UNITED STATES PATENT AND TRADEMARK OFFICE

APPLICATION NO.	FILING DATE	FIRST NAMED INVENTOR	ATTORNEY DOCKET NO.	CONFIRMATION NO.
10/699,335	10/31/2003	Anthony J. Cafferata	J-3763	5399
28165	7590	06/19/2007		
S.C. JOHNSON & SON, INC. 1525 HOWE STREET RACINE, WI 53403-2236			EXAMINER FIDEI, DAVID	
			ART UNIT 3728	PAPER NUMBER
			MAIL DATE 06/19/2007	DELIVERY MODE PAPER

Office Action Summary

DETAILED ACTION

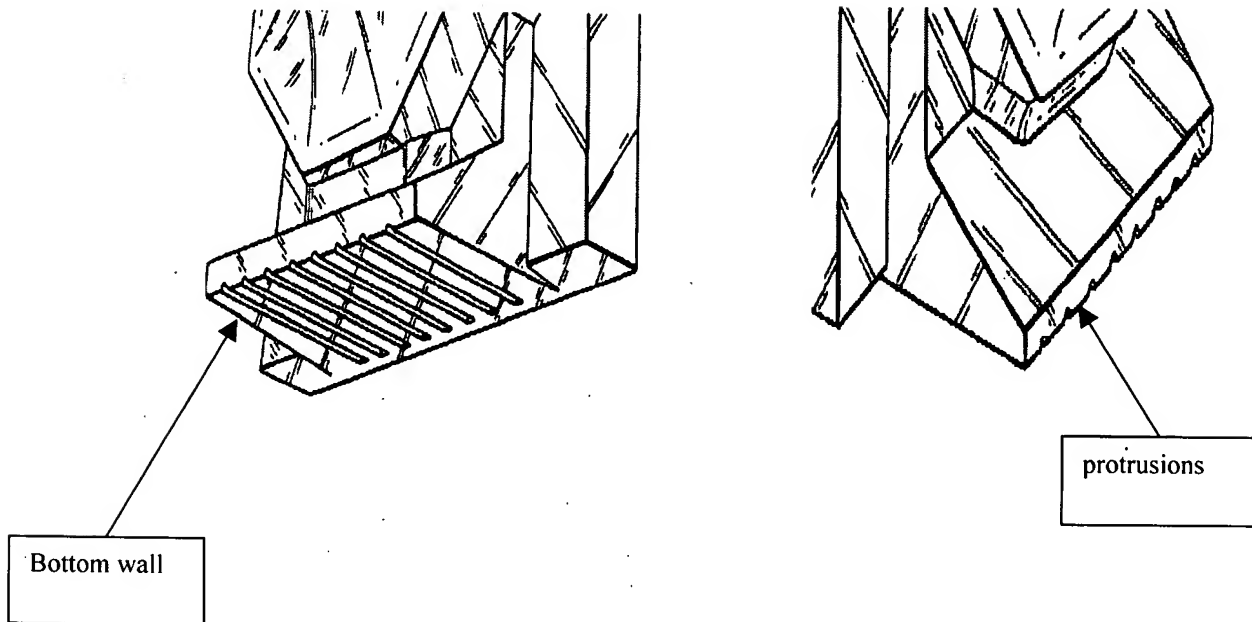
As to the newly amended subject matter, a package wherein said first outward projecting portion includes a bottom wall having integral therein at least two spaced apart downward protrusions, see the figure below where protrusions are defined on the bottom.

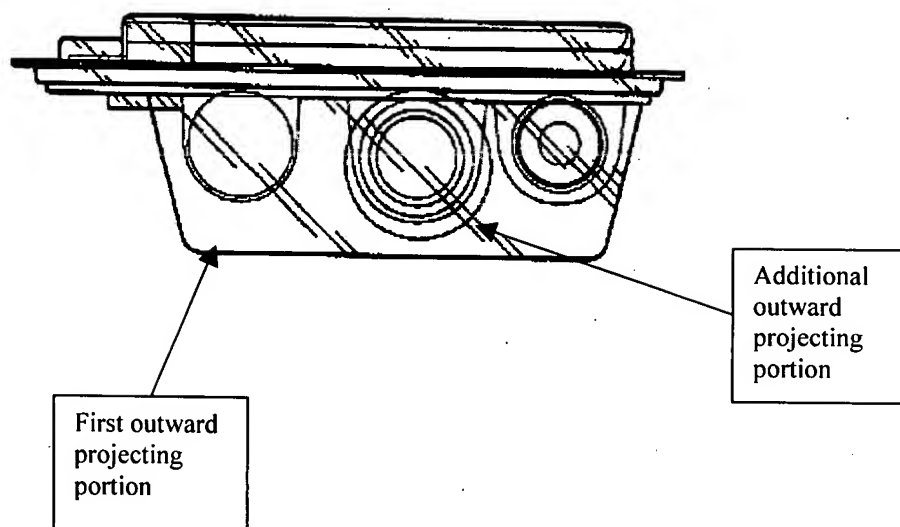
As to claims 7 and 8, a package according to claims 1 and 2 is shown where the first outward projecting portion includes a front wall of uniform depth.

FIG. 1

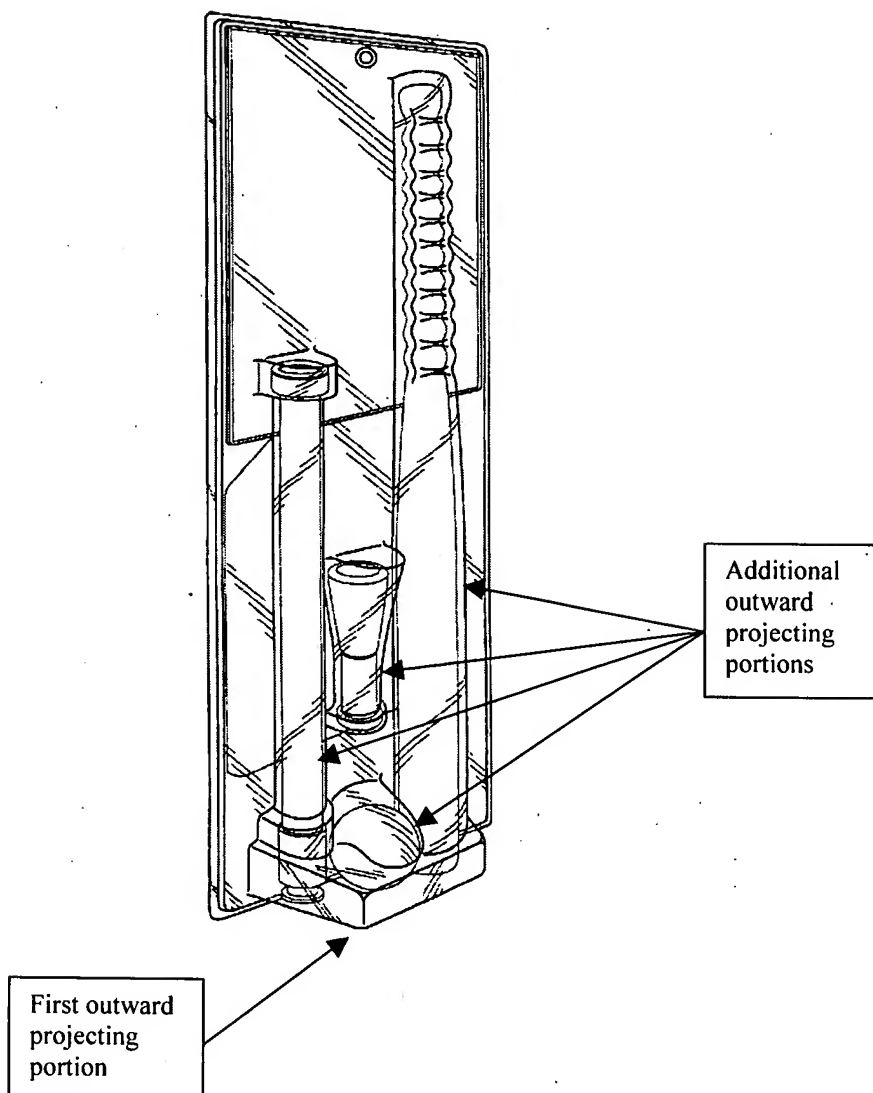
As to the newly added first outward projecting portion including a bottom wall having integral therein at least two spaced apart downward projections, Glassman discloses a clamshell package including a clamshell member 12 including two feet 38, 40 as shown in figure 1. It would have been obvious to one of ordinary skill in the art to modify the first outward projecting portion of Udwin by constructing at least two spaced apart downward protrusion as taught by Glassman, in order to form feet for supporting the package in the upright position.

As to claim 15 and 16, a package is shown in the figure where said at least one additional outward projecting portions are present, on either side of the middle additional projection portion, wherein said two of said at least two additional outward projecting portions are of different depths from each other.
